CITY OF TACOMA

ADDENDUM NO. 1

Specification No. PW21-0733F

Puyallup River Bridge Upgrades (MP 0.5C)

Bid Item 10: Install new wire rope handrail, steel railing posts

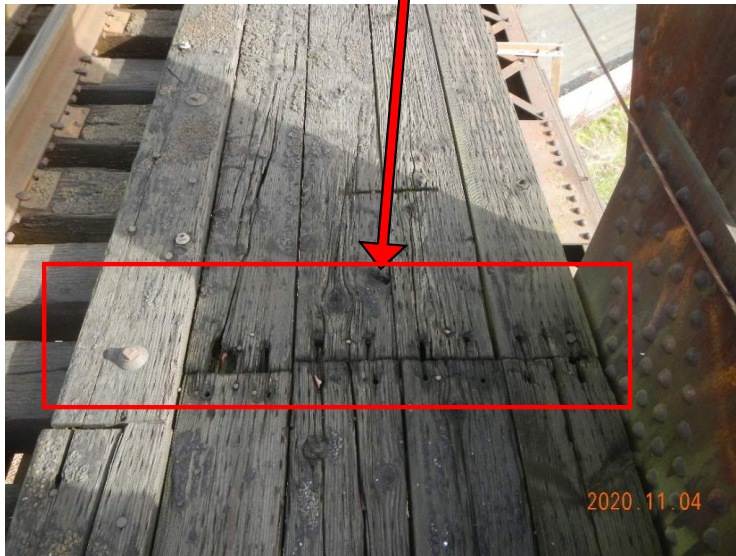
Walkway on Steel Truss Span

Walkway on Steel DPG spans over River

Bid Item 11: Spot Replace Treated Timber Walk Planks

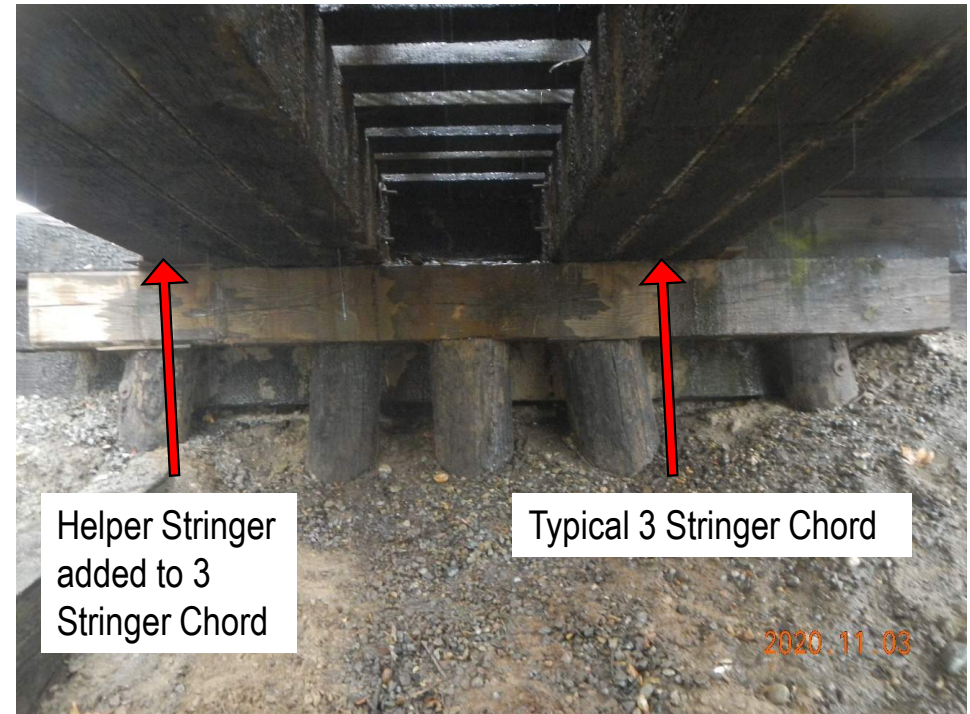
Typical decayed and failed walkway planks

Bid Item 13: Clean debris from Steel DPG Spans

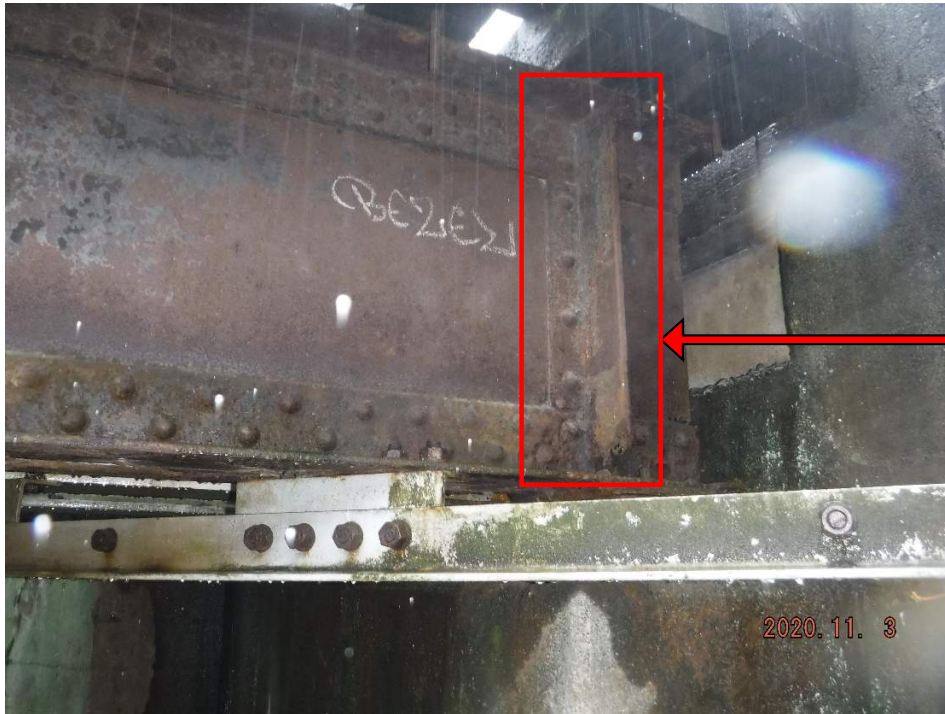
Debris accumulation on
Girder Top/Bottom
Gussets and Bearings

Debris to be collected
and not permitted to
enter waterway.
